Incredible Fashions Ltd. (Extension)

Building information:

Storage Building: This structure is a five storied (G+4) reinforced concrete (RC) building.

Pile Layout Plan

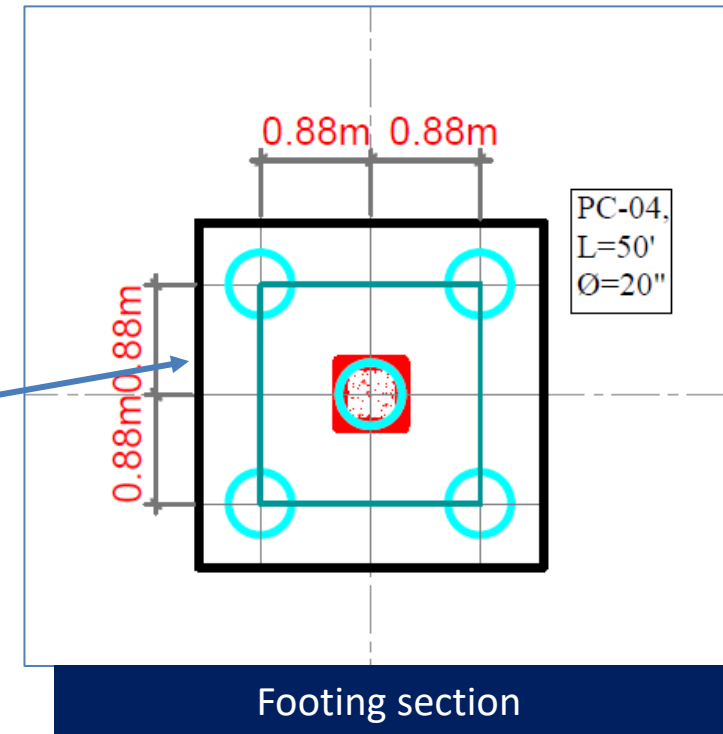
Cursory calculation indicates that bearing capacity of few piles exceeds the normal design limit considering 6 kPa live load on typical floors. Building engineer to review design, loads and foundation stresses.

Corrosion on exposed rebar

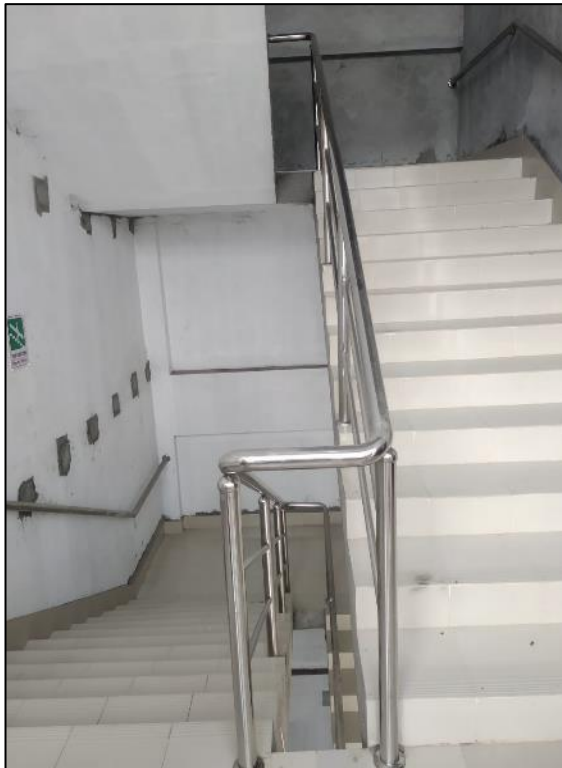
Exposed rebar was observed at the roof of the utility building.

Building engineer is required to provide protective coating on the exposed rebar to protect from corrosion.
